**Design Review Board**  
**Regular Meeting**  
**Agenda**

Thursday, October 2, 2025

**DESIGN REVIEW BOARD  
COMMUNICATION**

Business Item V.A  
**Approval of Backyard Shed**

SITE PLAN

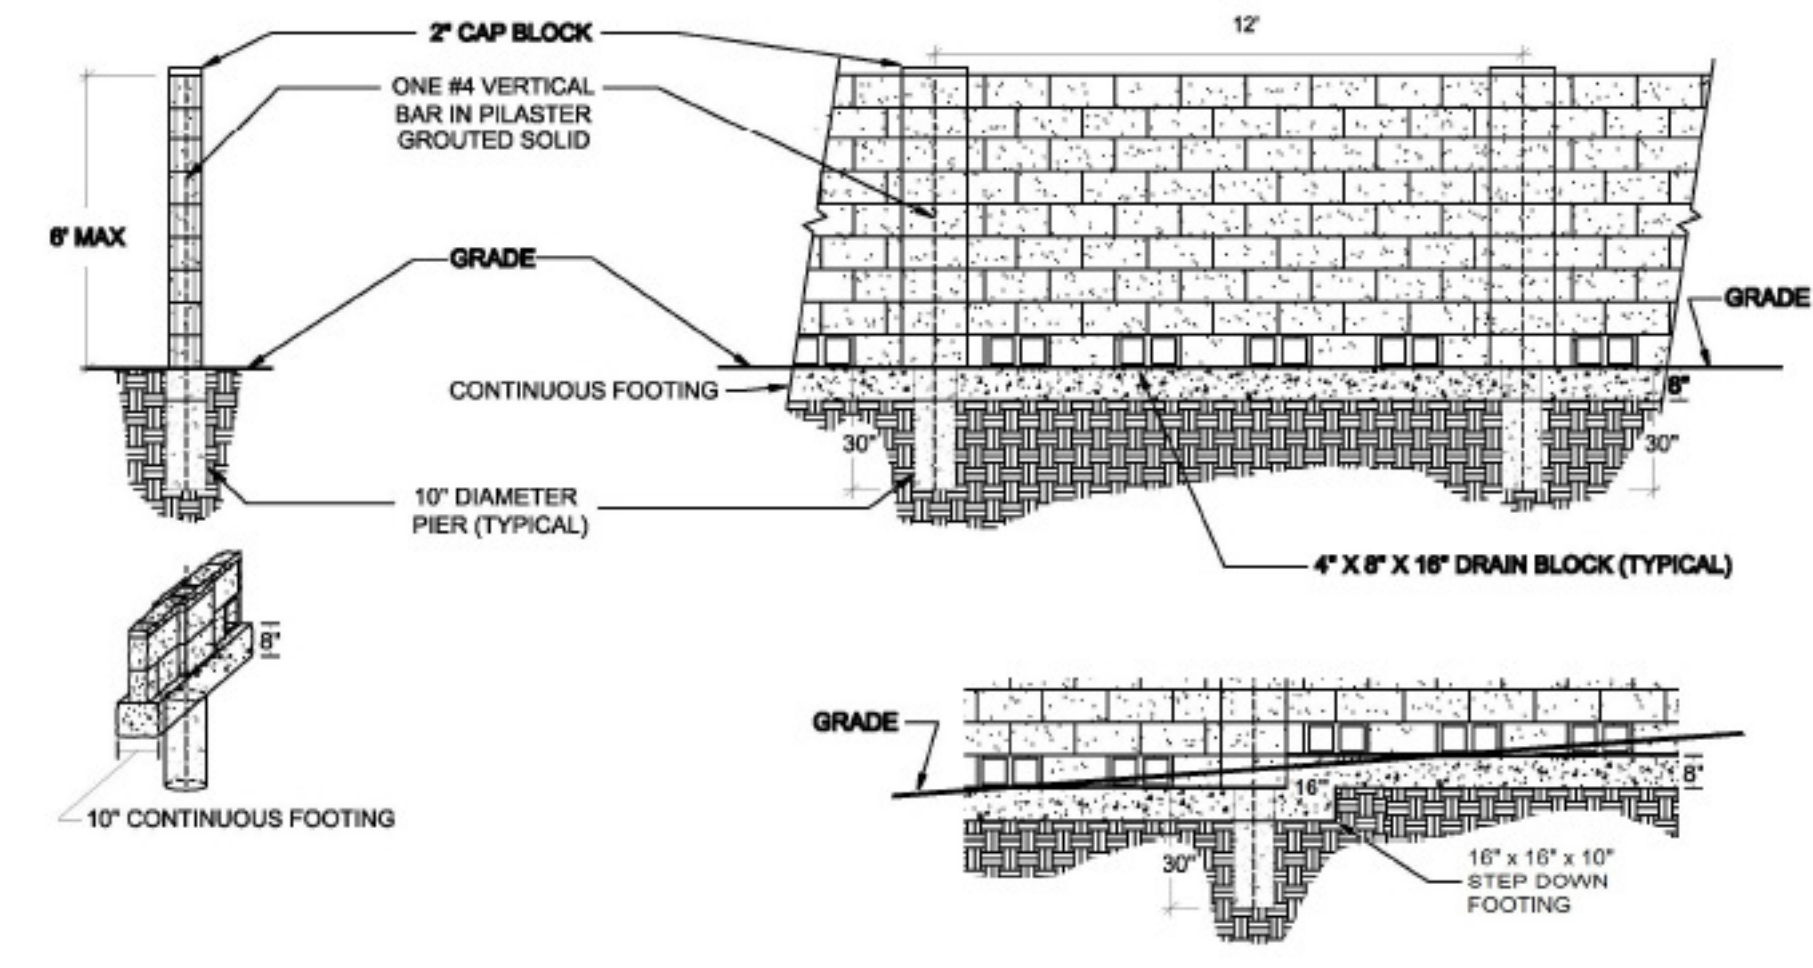
The applicant is proposing to change the existing Arizona Room to livable space in the rear yard of the home, along with updating the concrete shingle roof back to asphalt shingles to reduce the dead load, and replace the existing chain link fence with concrete block, unfinished to match the adjacent homes along the rear alley, to also include a gate for vehicular entry. The proposed conversion will utilize matching siding material found in the front of the home as the facade is a mix of materials. The updated shingles will create a classic feel consistent with the surrounding homes. The updated wall request will require DRB approval to not include stucco and paint. The gate can be permissible, but no RV storage is permitted.

NEAL KTSILENCE MS&B  
390 E. CAMPINADR. NEW PERGOLA

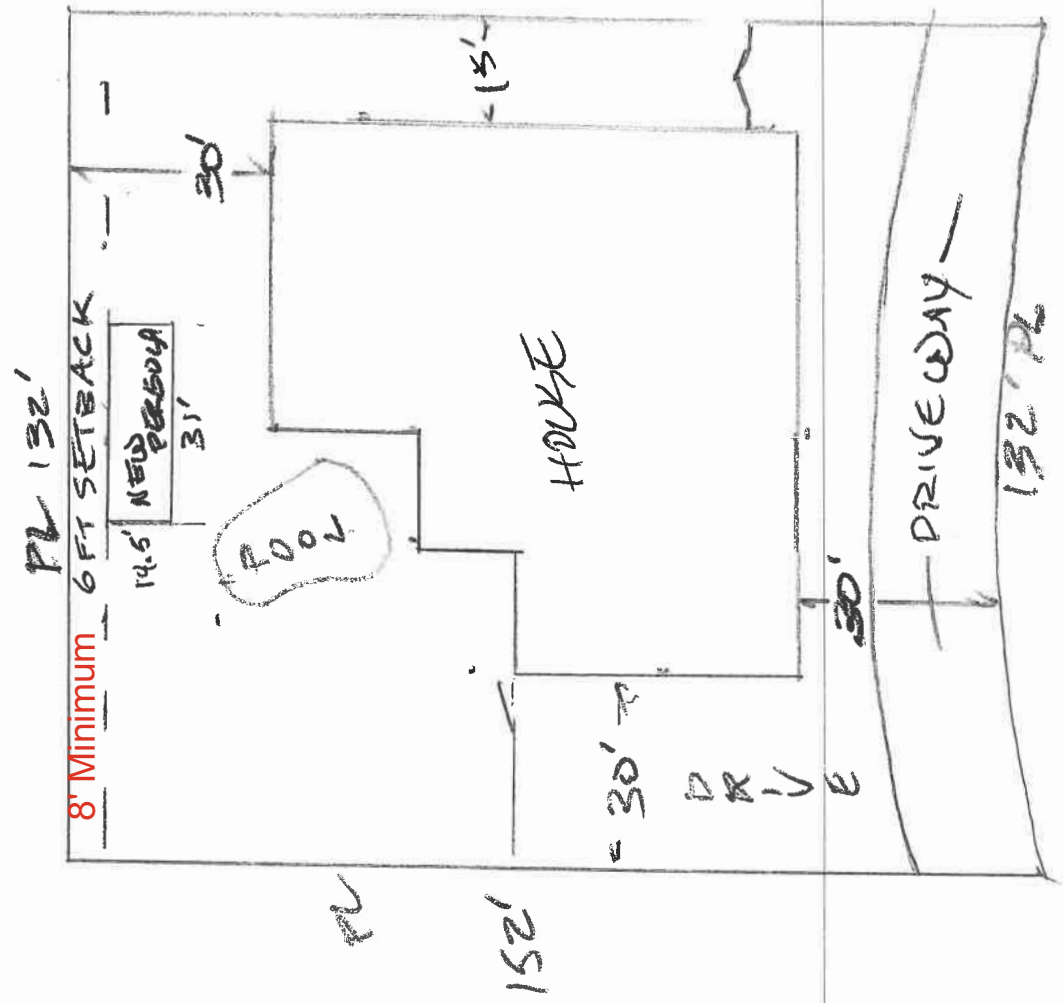
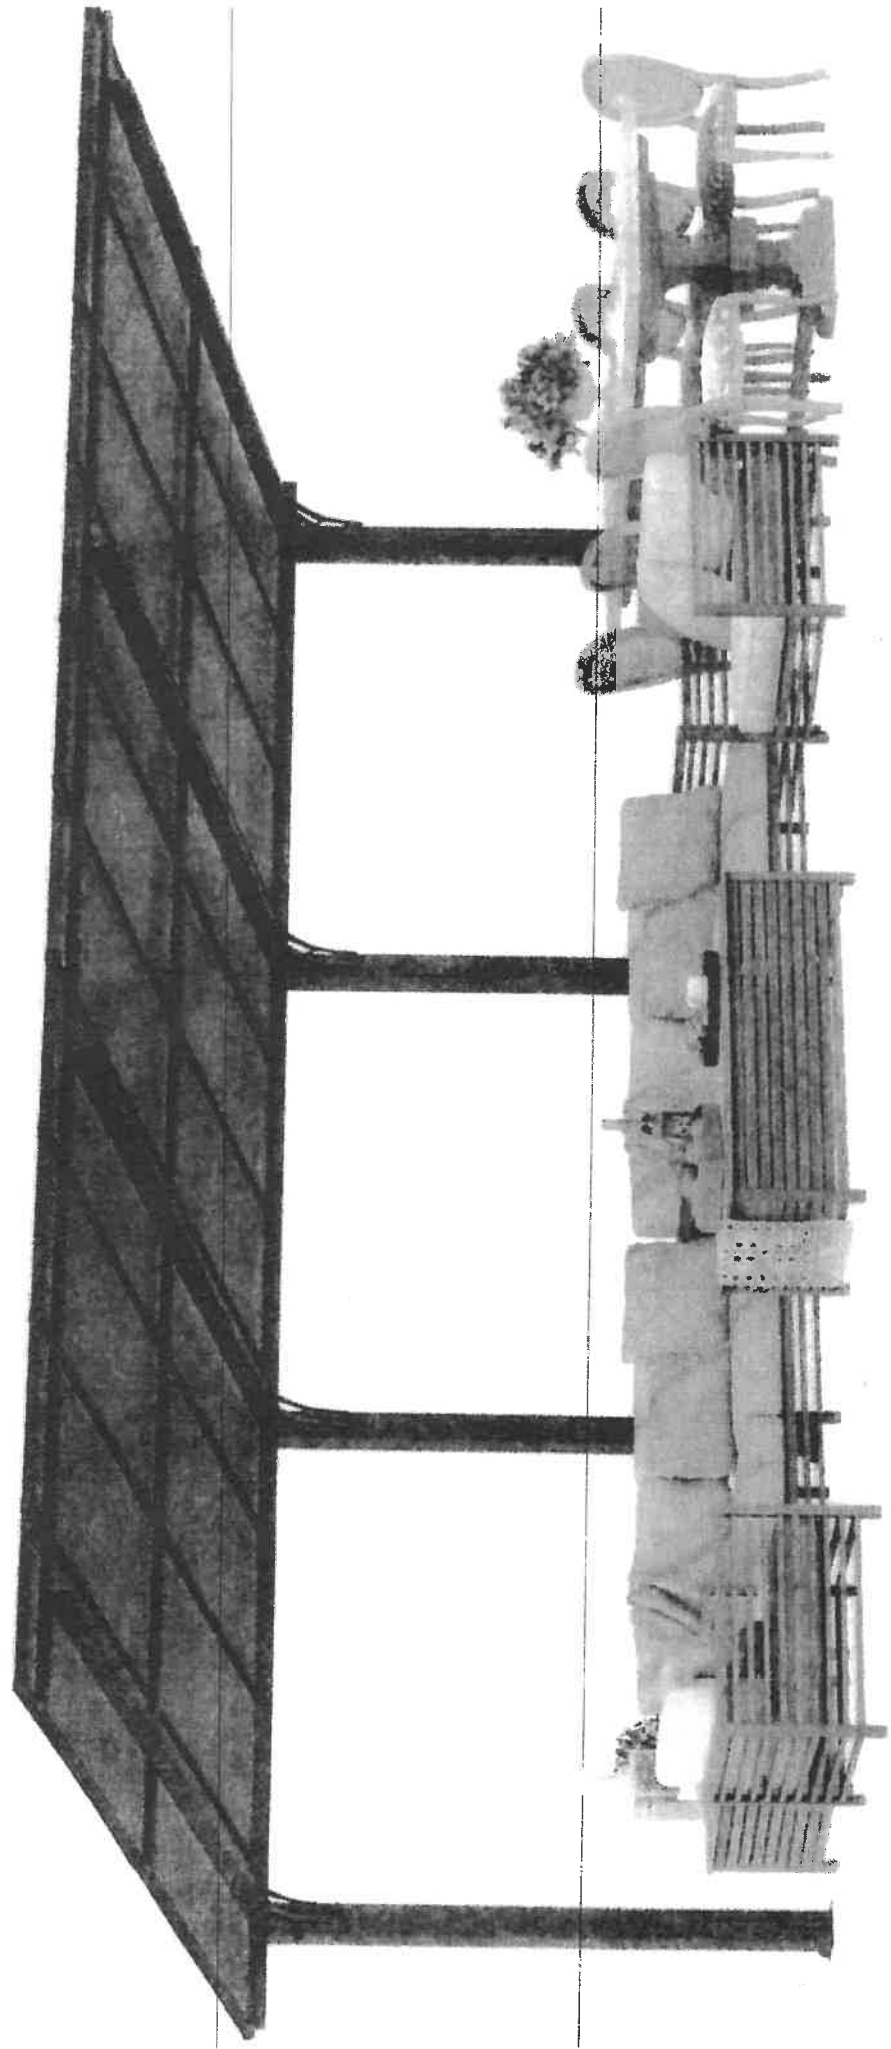
The applicant is proposing a large pergola in the rear yard against Camelback Road. The pergola will cover an existing improved space. The property is burdened by a public utility easement requiring an 8' separation from the rear yard. This will require a 2' adjustment back towards the home. The proposed size and location has room to make the adjustment. The pergola will compliment the home's architecture.

1. A Building Permit issued by the City will be required before any construction is to occur.
2. Provide a minimum setback of at least 8 feet from the rear property line in order to accommodate the public utility easement.
